9.5 Other Auxiliary Systems

The information in this section of the reference ABWR DCD, including all subsections, tables, and figures, as modified by the STP Nuclear Operating Company Application to Amend the Design Certification rule for the U.S. Advanced Boiling Water Reactor (ABWR), "ABWR STP Aircraft Impact Assessment (AIA) Amendment Revision 3," dated September 23, 2010 is incorporated by reference with the following departures and supplements.

STD DEP T1 3.4-1	STD DEP 9.5-2 (Figure 9.5-3, replaced entire figure)
STP DEP 1.1-2 (Figures 9.5-2, 9.5-4 and 9.5-5)	STD DEP 9.5-3
STP DEP 1.2-2 (Table 9.5-5)	STD DEP 9.5-4
STD DEP 8.3-1	STP DEP 9.5-6 (Figure 9.5-6)
STD DEP 9.4-2 (Table 9.5-5)	STP DEP 9.5-7 (Table 9.5-5)
STD DEP 9.5-1	STD DEP Admin

Figure 9.5-2 Outline - Telephonic Communication System for Single Unit of STP 3 or 4

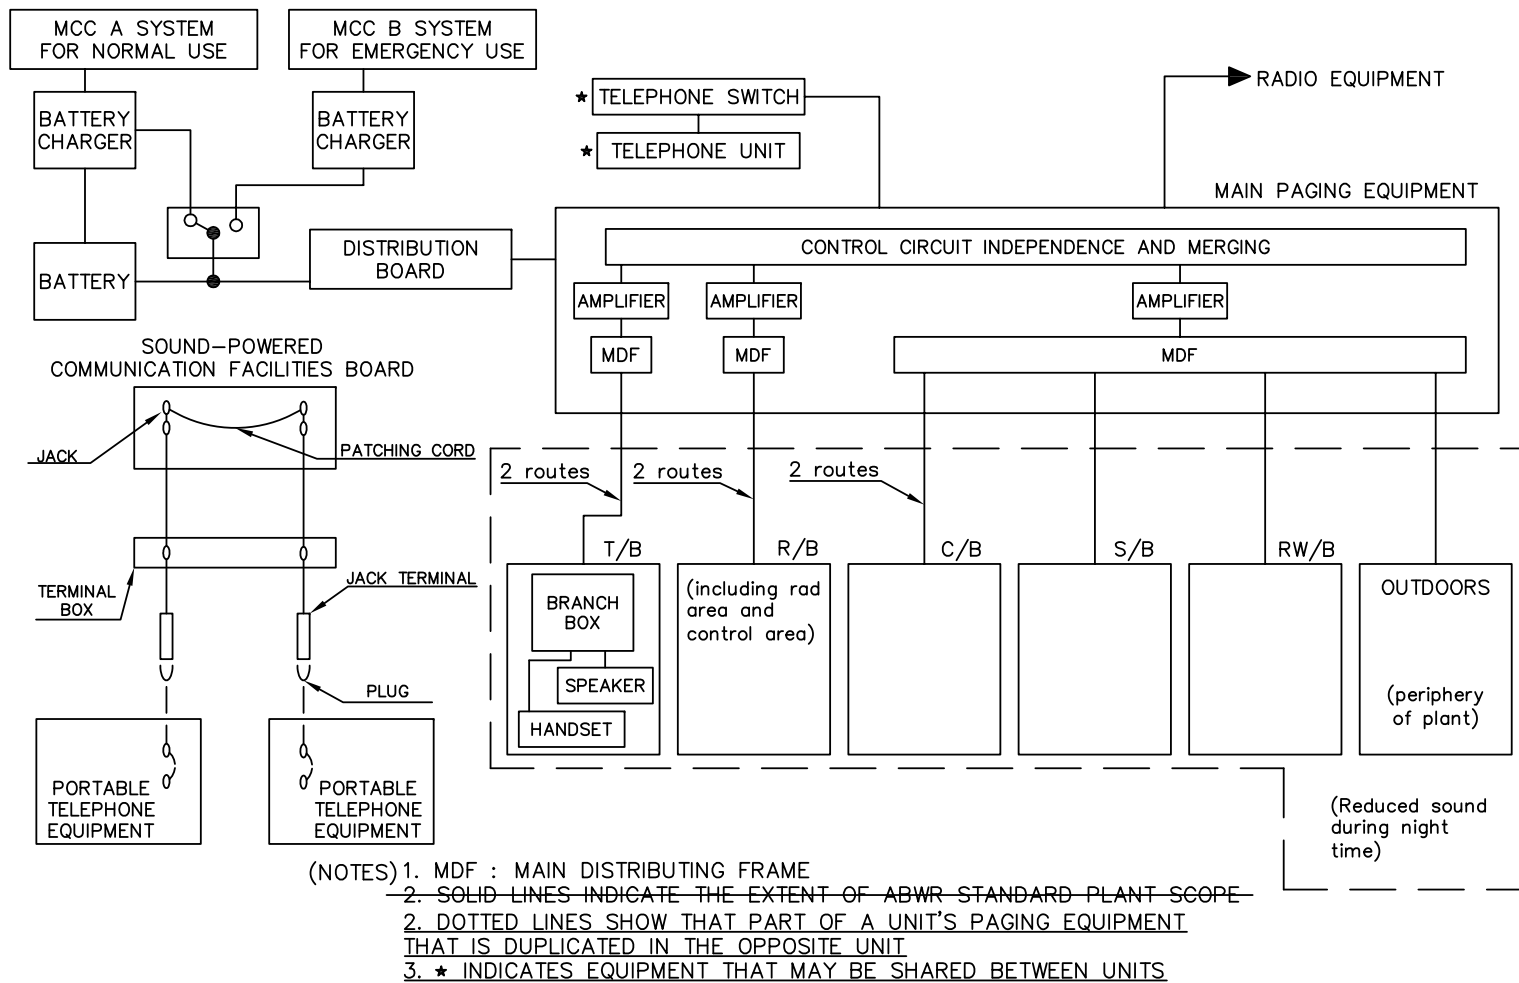
At STP 3 & 4, a common communication system is used to provide plant-wide communications between the dual units. The communication system is not safety-related. A common communication system providing plant wide communications is a safety enhancement since it allows for ease of communication between units. The representative outline of the common communication system is shown in Figure 9.5-2 for STP 3 & 4.

Figure 9.5-3 Lower Drywell Flooder System Arrangement/Configuration

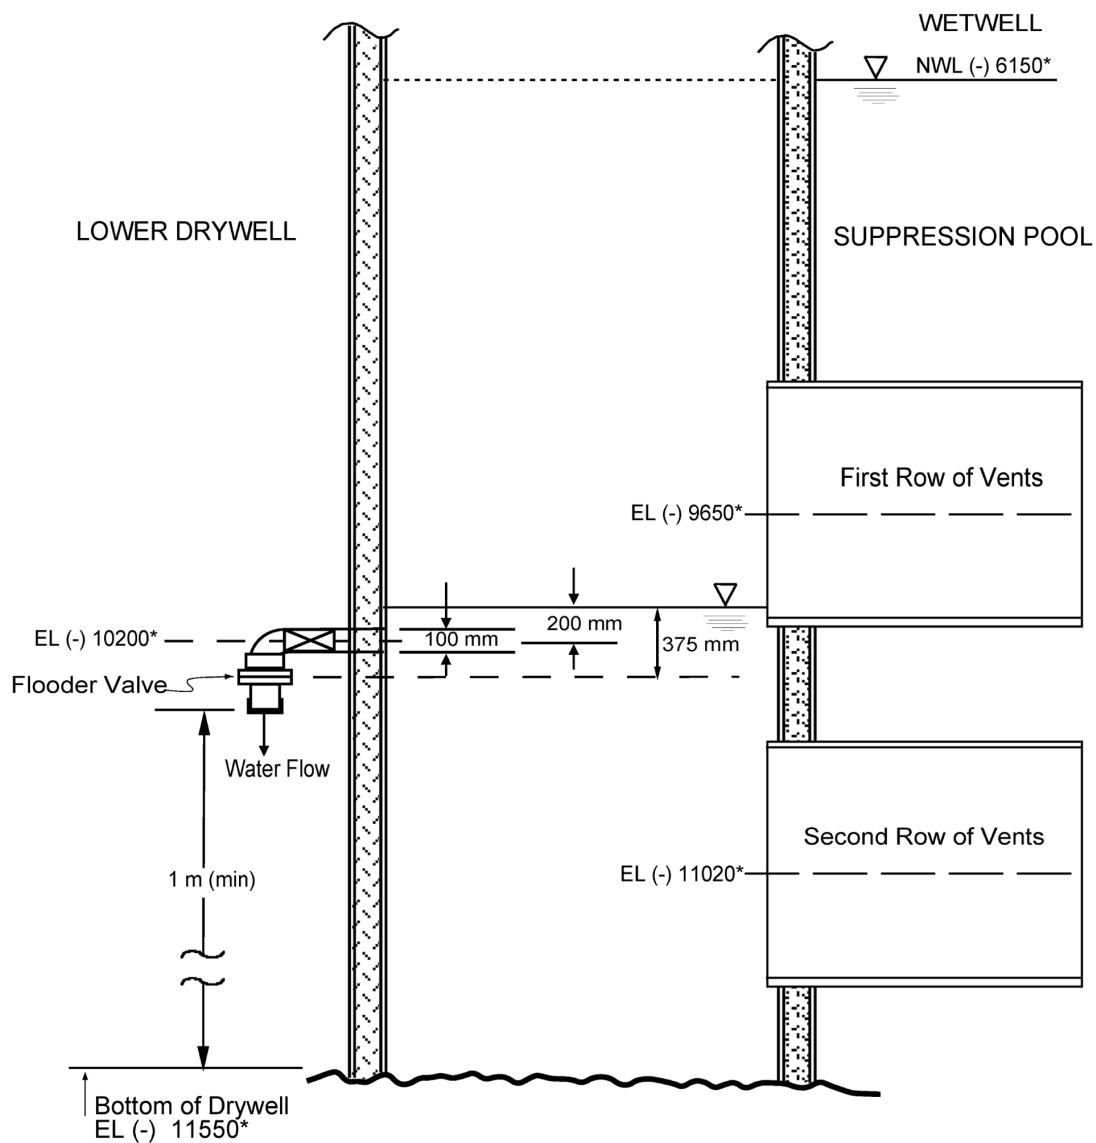
The LDF, shown schematically in Figure 9.5-3, provides a flow path for suppression pool water into the lower drywell area during severe accident scenario that leads to core meltdown, vessel failure, and deposition of molten corium on the lower drywell floor. Molten corium is a molten mixture of fuel, reactor internals, the vessel bottom head and control rod drive components. The flow path is opened when the lower drywell airspace temperature reaches 260°C.

The LDF consists of ten pipes that run from the vertical pedestal vents into the lower drywell. Each pipe ~~contains~~ has an isolation valve and a fusible plug valve connected to the end of the pipe that extends into the lower drywell ~~by a flange~~. The fusible plug valves open when the drywell air space ~~(and subsequently the fusible plug)~~ temperature reaches 260°C. When the fusible plug valves open, a minimum of 10.5 L/s of suppression pool water will be supplied through each floodor pipe (105 L/s total) to the lower drywell to quench the corium, flood the lower drywell and remove corium decay heat, which is estimated at 1% of rated thermal power. The flow rate is based on a minimum hydrostatic head of 200 mm above the floodor pipe inlet centerline and takes the frictional losses through the floodor pipe and fusible plug valve into account.

Figure 9.5-4 Fire Protection Water Supply System

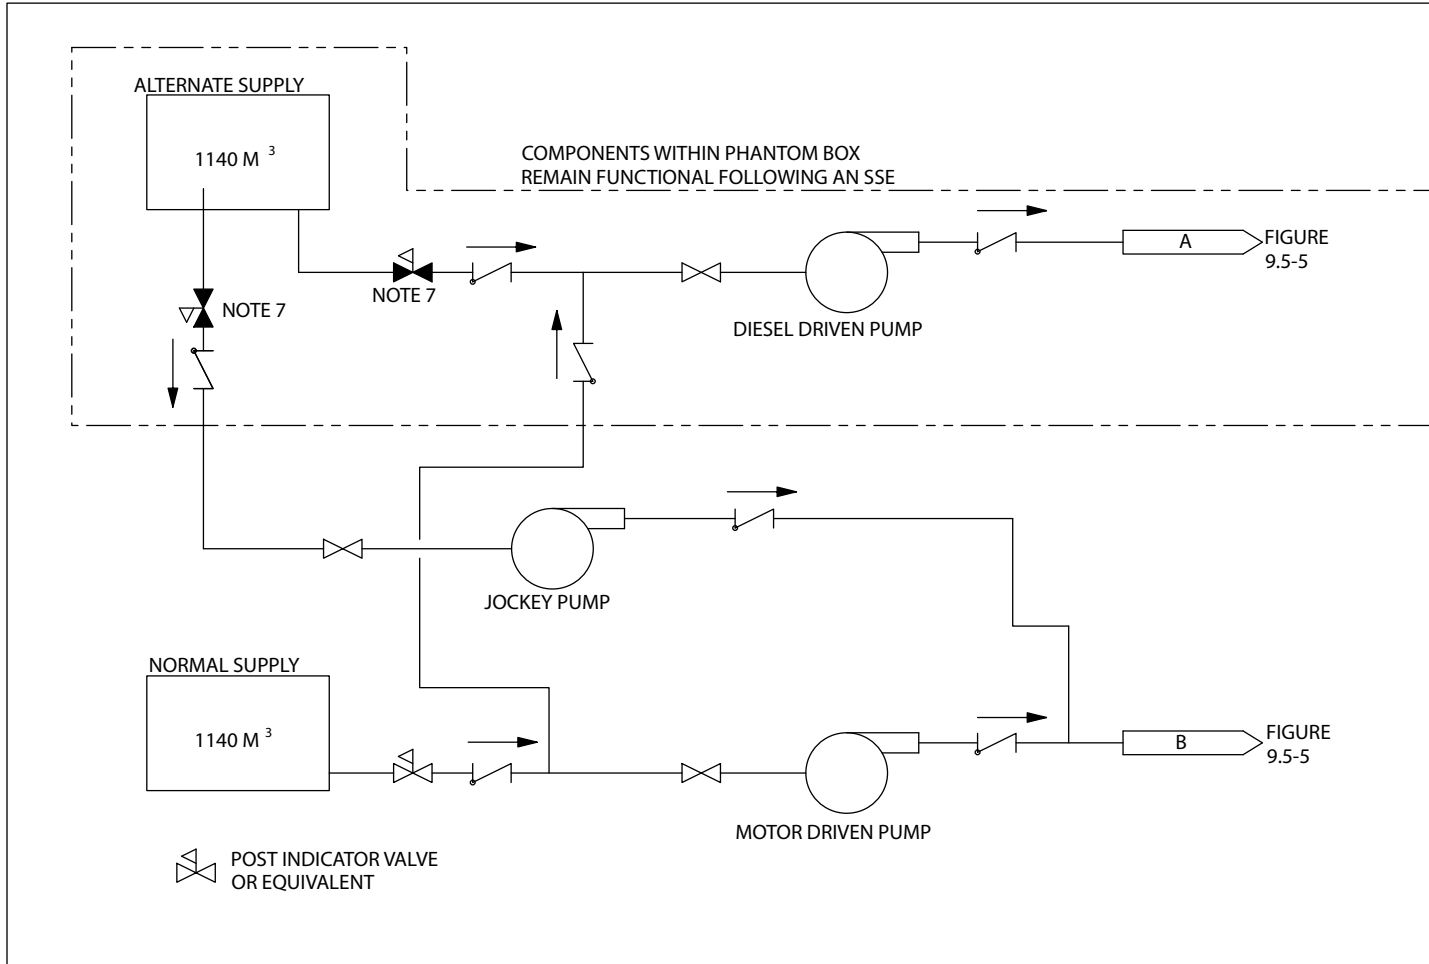
STP 3 & 4 is a dual-unit station. The water supply for fire protection will be shared by STP 3 & 4. A single fire protection pump house and two storage tanks are located within the protected area boundary that provides water for fire suppression to both units via piping in the yard. This common system has the same capability as the system for the single unit design. The fire protection water supply complies with Regulatory Guide 1.189, Rev. 1, which states that a common water supply may be utilized for multi-unit nuclear power plant sites with a common yard fire main loop. The common fire water supply and yard main piping system for STP Units 3 & 4 are depicted in Figures 9.5-4 and 9.5-5. The common yard fire main loop surrounding STP Units 3 & 4 is cross-connected between units in accordance with Regulatory Guide 1.189, Rev. 1.
